October, 2003

## Product Bulletin Improvement to Manual Reset Mechanism On 150S/157S Level Controls

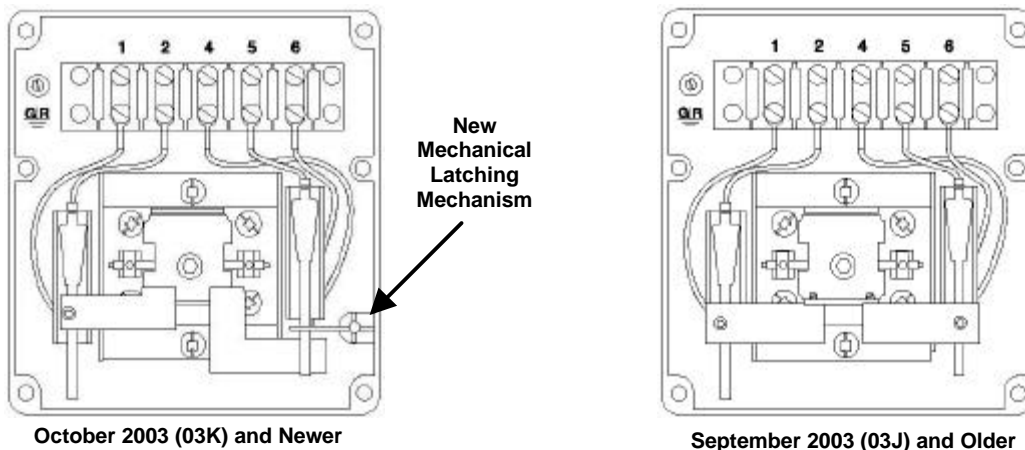
McDonnell & Miller is pleased to announce an improvement to the manual reset versions of the Series 150S/157S products with products manufactured beginning in October 2003 (date code 03K). The change involves replacing the existing button type microswitch with a mechanical latching mechanism. This is a more robust design which will address the occasional problems you have seen with hard to reset controls. The diagrams below show the location of the reset mechanism and change to the bracket mechanism.

- Replacement switch assemblies (SWA-150S-M and SWA-158S-M) for units manufactured prior to October 2003 (03K) will no longer be offered. A replacement head would need to be purchased which will upgrade the unit to the new design.
- Units manufactured October 2003 (03K) and beyond will use the SWA-150S replacement switch assembly if replacement of switches is necessary.
